Access Compliance Report Public Rights-of-Way (Island Curb Cuts)

Intersection ID: 10025976 Main Street: ELM LN **Cross Street: N/A** Location: W ADA ID: 0D5016DFBD6E Curb Cut Type: MedianRefuge2 Initial Pass/Fail: Fail **Overall Compliance: No Severity Score:** 0

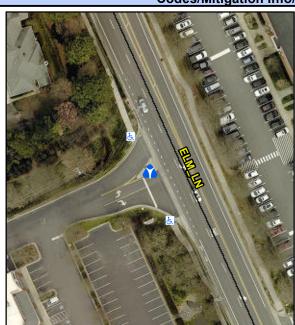
Com	pliance Description	Data Co	mpliance Description
Yes	Refuge 1 Length (In)	54.0 N/A	Gutter 1 Ponding?
Yes	Refuge 1 Width (In)	95.5 N/A	Gutter 1 Lip Ht (In)
Yes	Refuge 1 Slope (%)	0.8 N/A	Gutter 1 Slope (%)
Yes	Refuge 1 X Slope (%)	3.9 N/A	Gutter 1 X Slope (%)
N/A	Painted X Walk1?	No N/A	N DWS 1 Provided?
N/A	X Walk 1 Direction	To NW N/A	DWS 1 Contrast?
N/A	X Walk 1 Width (In)	N/A N/A	N DWS 1 Length (In)
N/A	Road 1 Slope (%)	4.9 N/A	DWS 1 Full Width?
N/A	Road 1 X Slope (%)	1.2 N/A	DWS 1 Offset (In)
Yes	Refuge 2 Length (In)	54.0 N/A	Gutter 2 Ponding?
Yes	Refuge 2 Width (In)	95.5 N/A	Gutter 2 Lip Ht (In)
Yes	Refuge 2 Slope (%)	0.7 N/A	Gutter 2 Slope (%)
Yes	Refuge 2 X Slope (%)	3.7 N/A	Gutter 2 X Slope (%)
N/A	Painted X Walk2?	No N/A	N DWS 2 Provided?
N/A	X Walk 2 Direction	To SE N/A	DWS 2 Contrast?
N/A	X Walk 2 Width (In)	N/A N/A	N DWS 2 Length (In)
N/A	Road 2 Slope (%)	3.6 N/A	DWS 2 Full Width?
N/A	Road 2 X Slope (%)	1.8 N/A	DWS 2 Offset (In)

Remove & Replace Entire Refuge.
